GROWTH MANAGEMENT DEPARTMENT STAFF REPORT
VILANO BEACH TOWN CENTER OVERLAY DISTRICT

October 11, 2023 Public Meeting
VBTCDR 2023-05 Vilano Mixed Use

Architectural Review Comments
Vilano Beach Town Center
Beach at Vilano
VBTC DR 2023-05

Prepared by
Donald A. Crichlow, AIA
FL. Lic. AR0015950
September 20, 2023

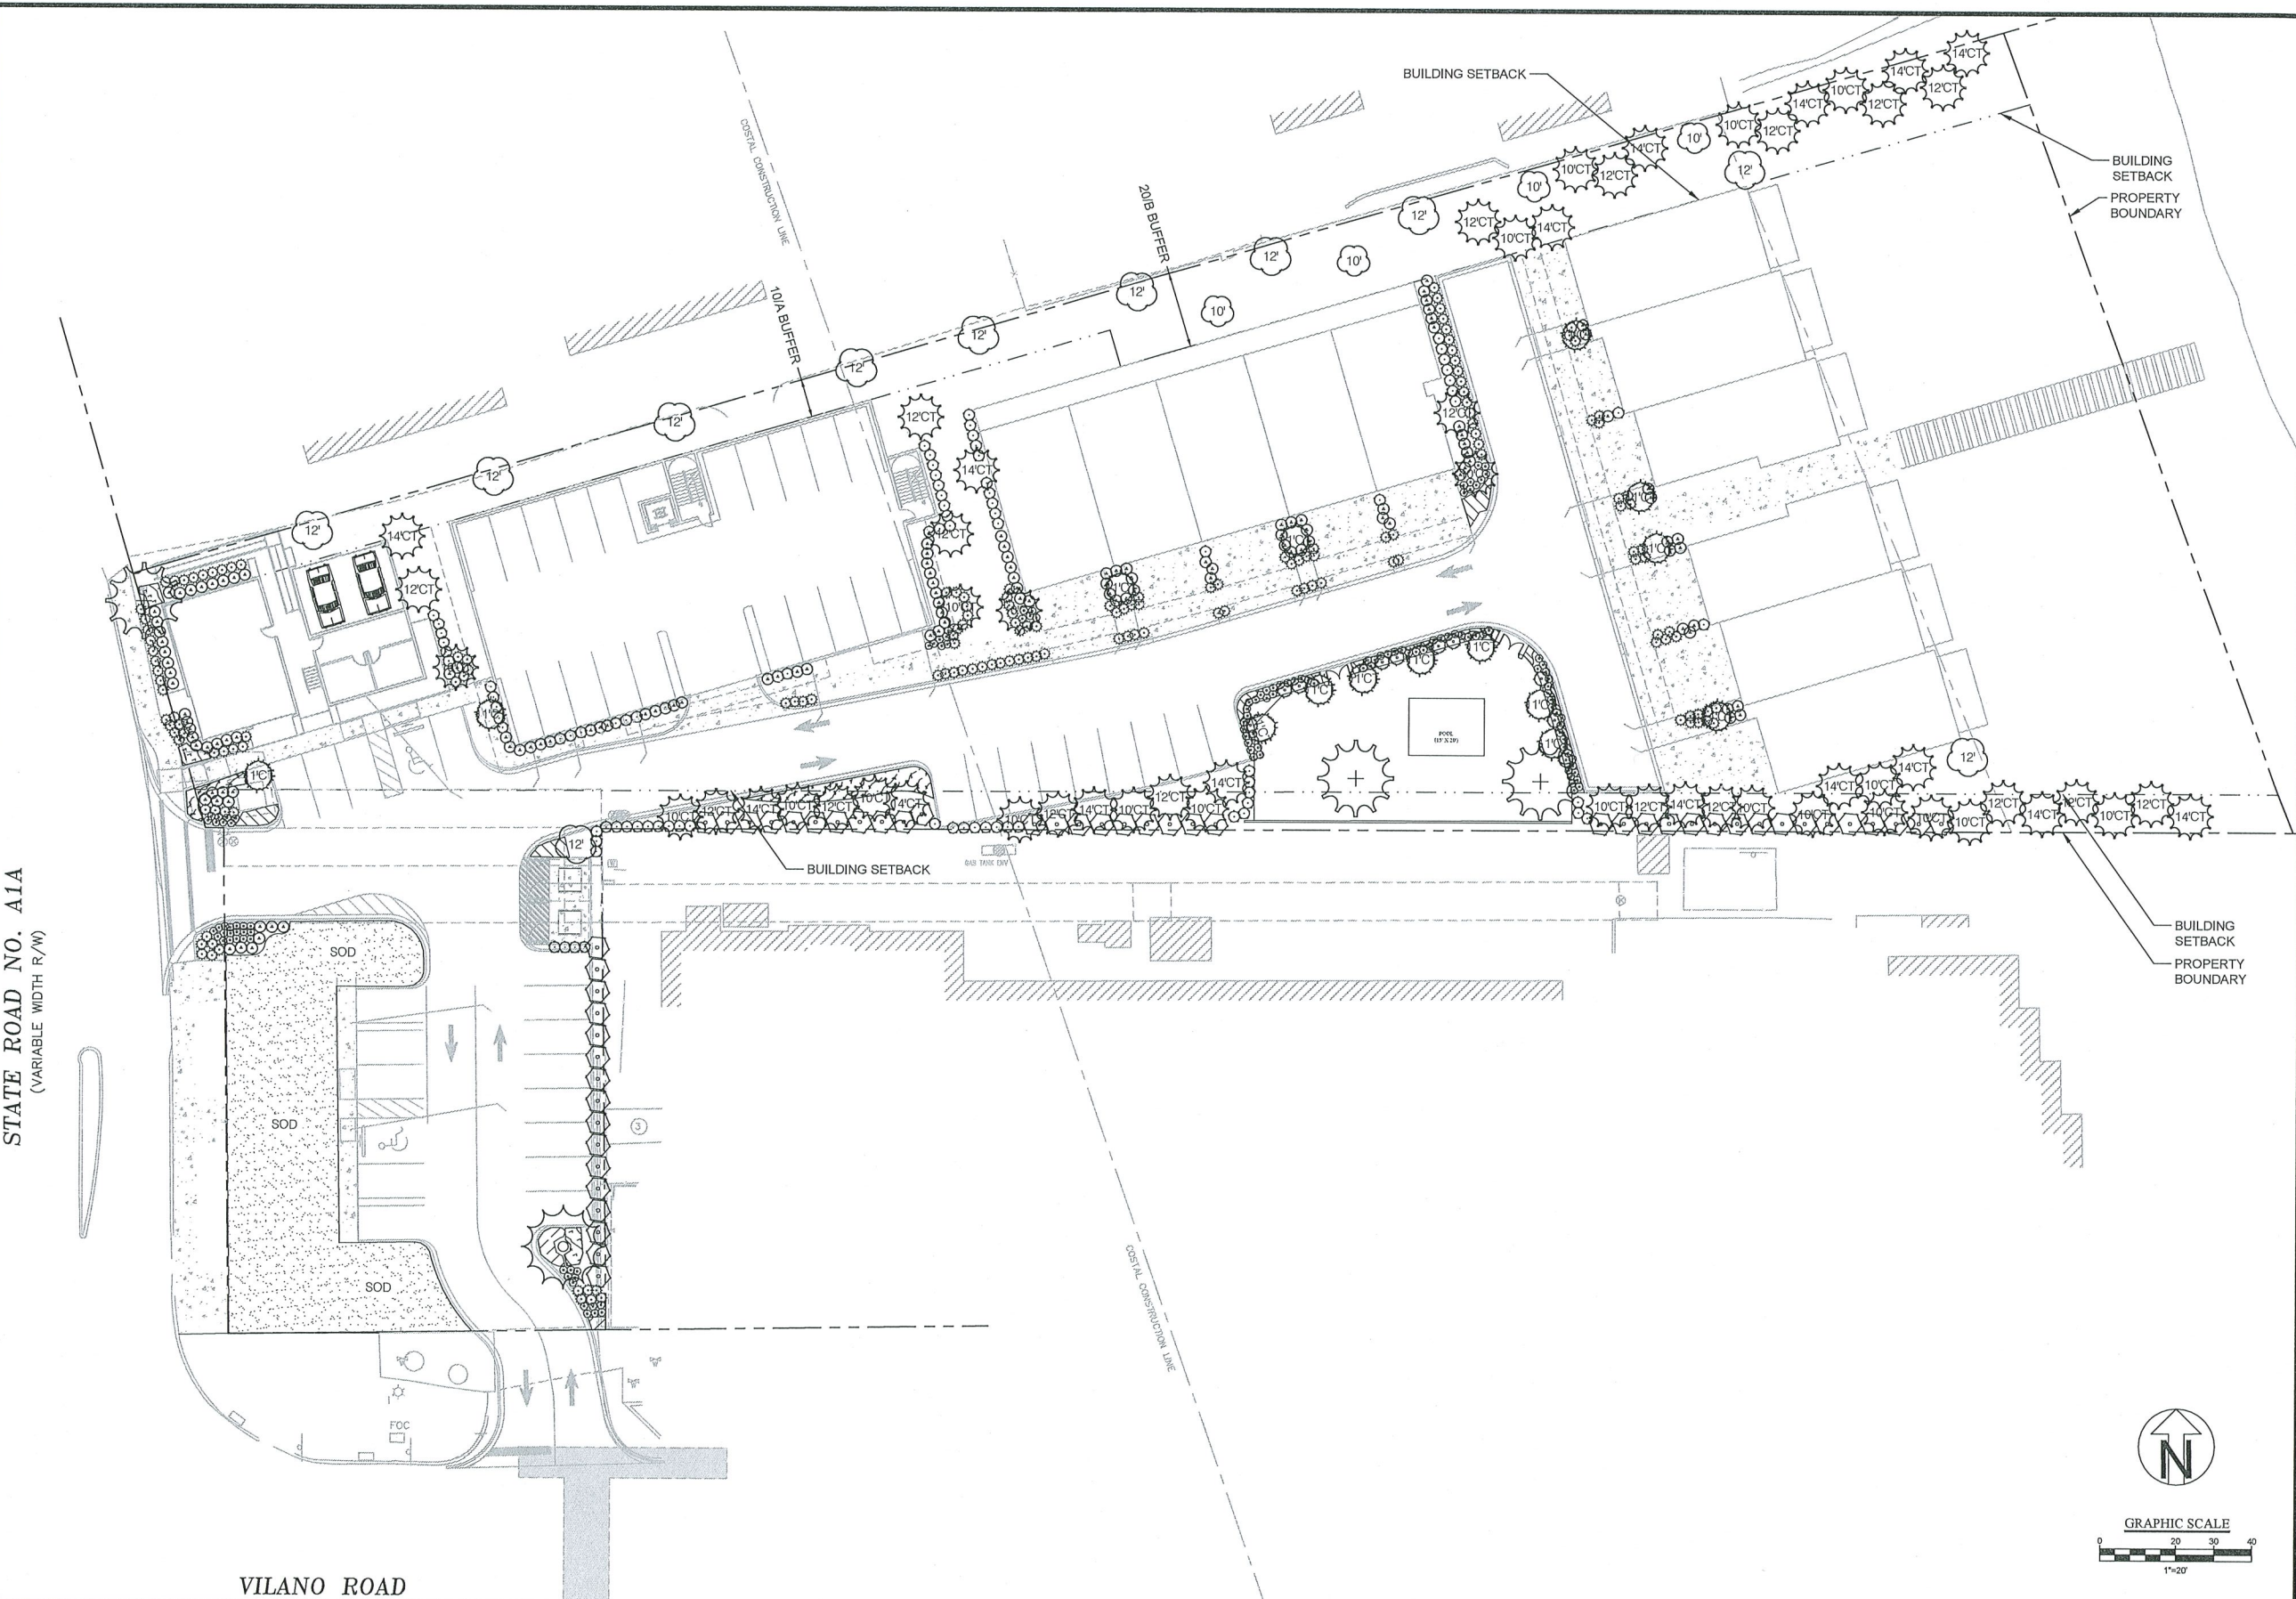
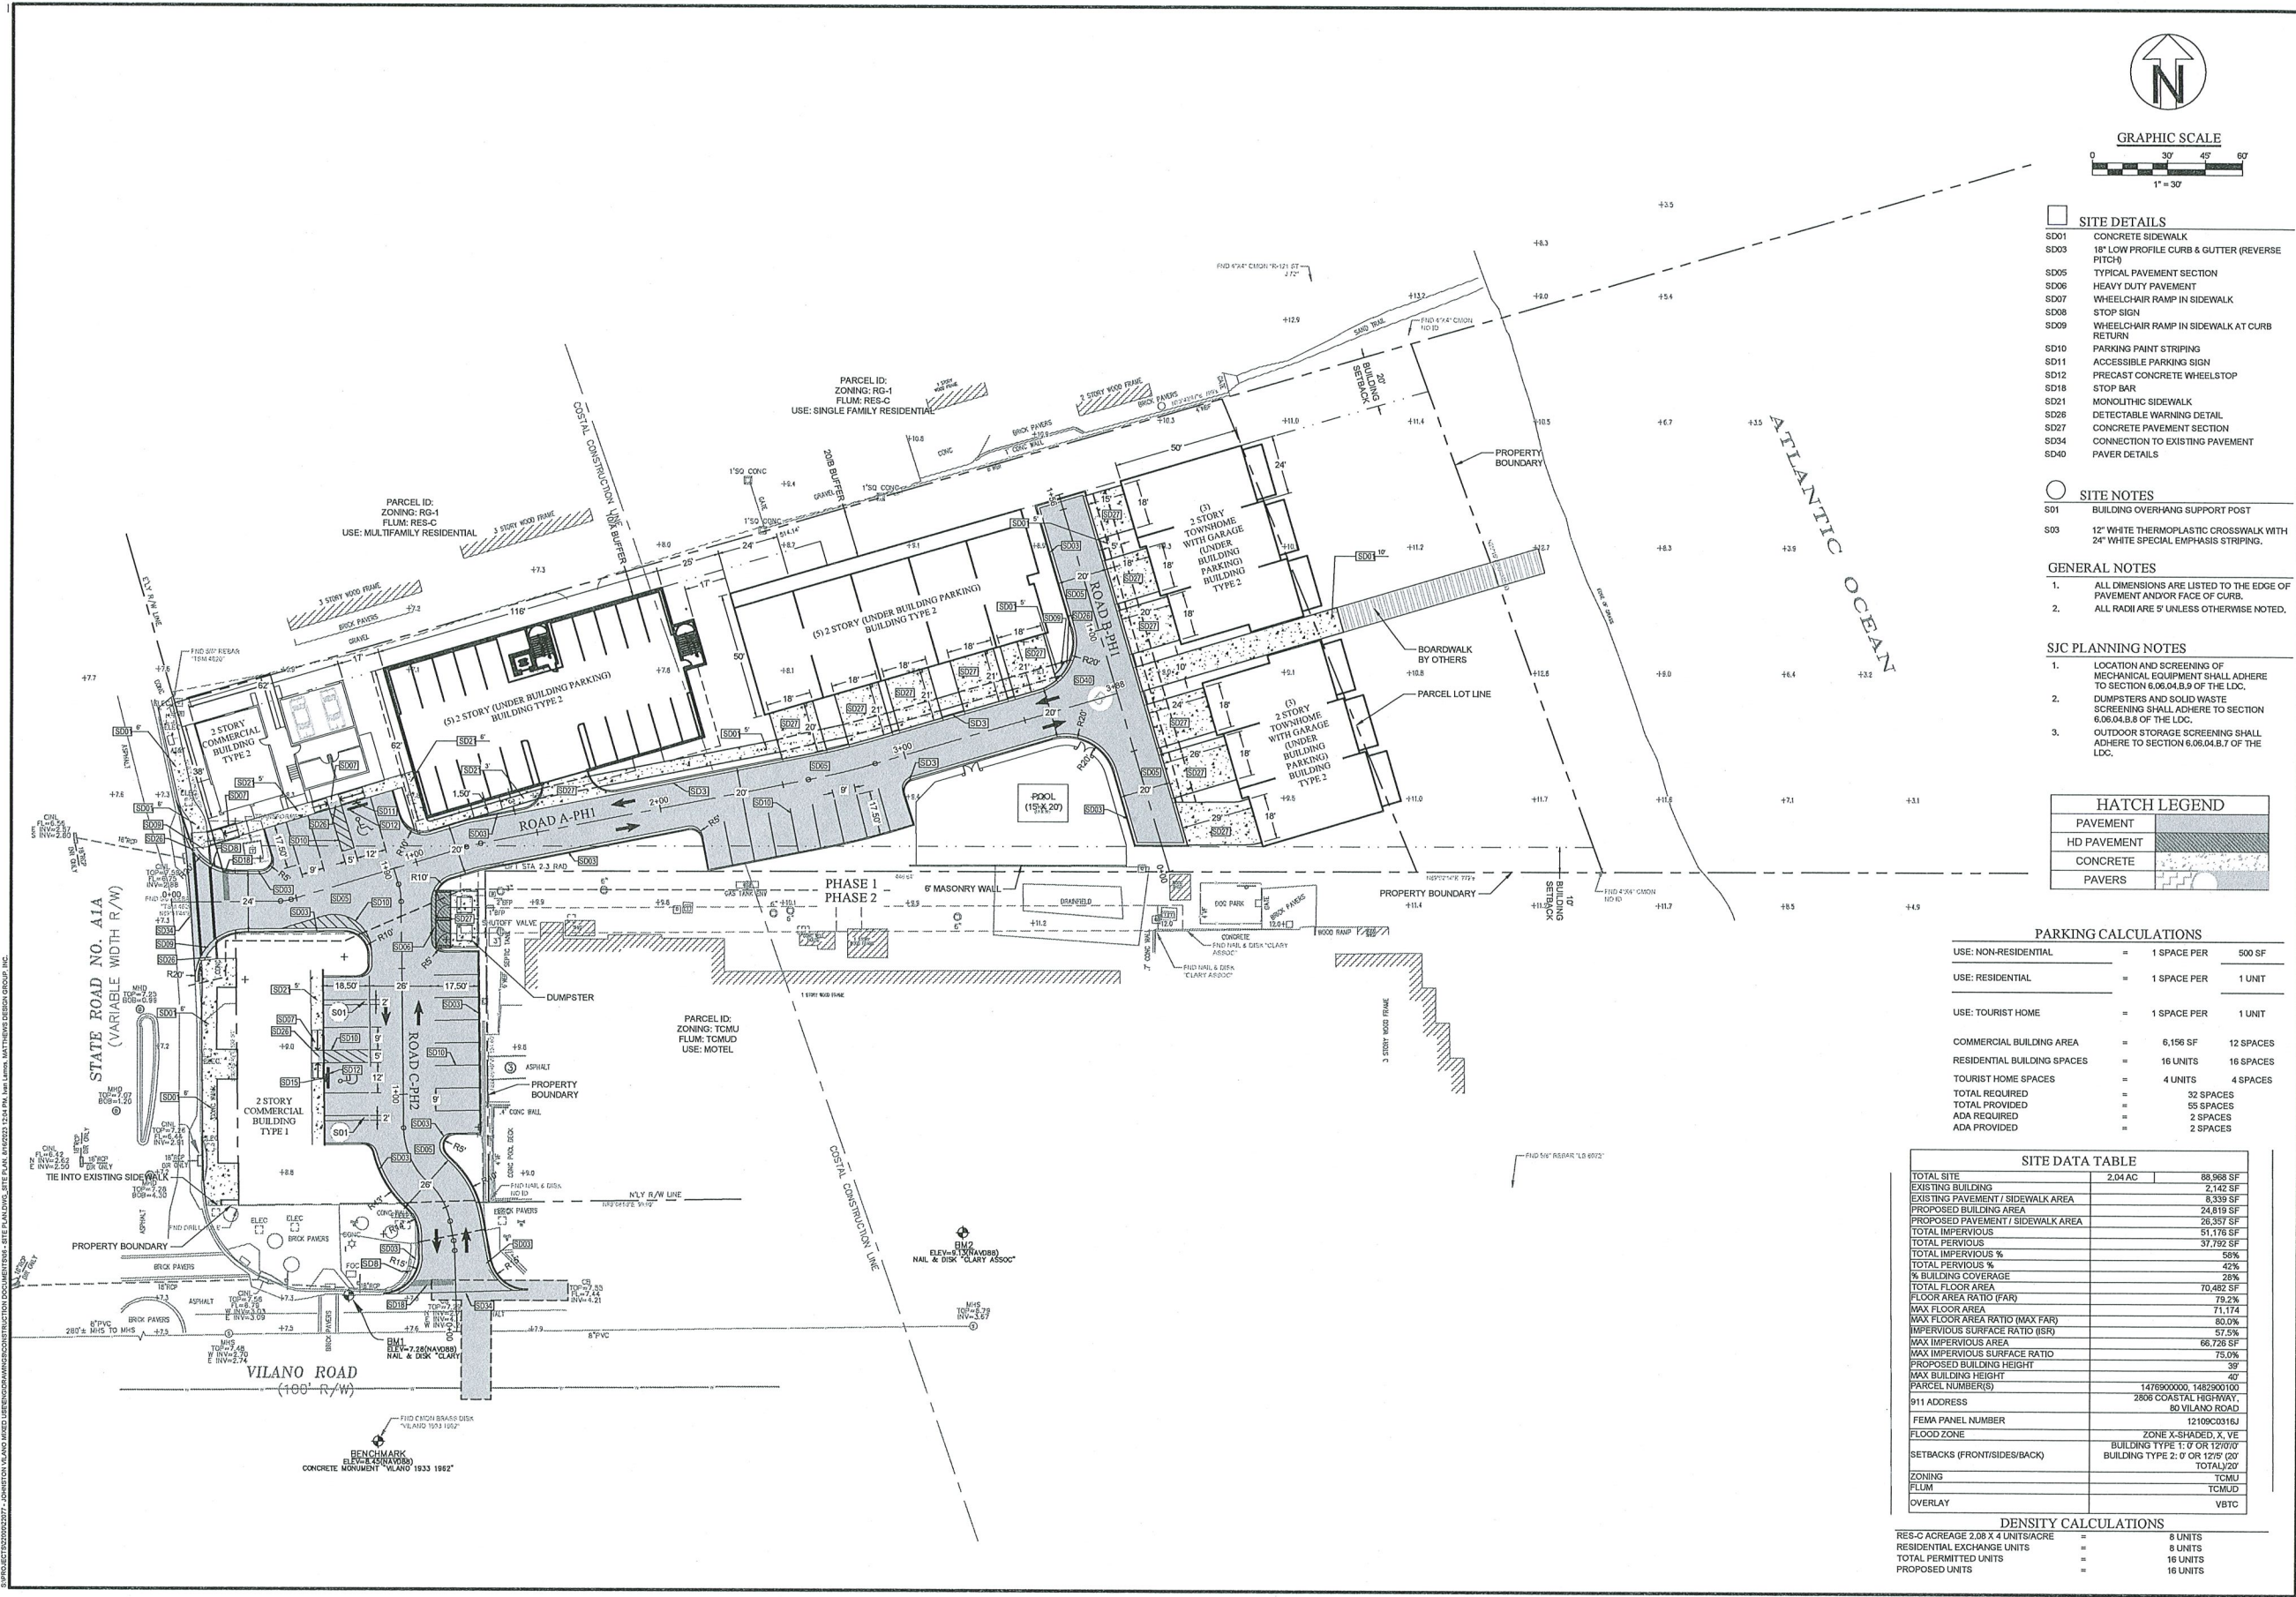
Section 3.10.05.L. Landscape. Landscaping, buffering and screening is proposed according to the LDC and TCMU regulations. A landscape site plan is provided. Landscape will be reviewed with the construction plans.
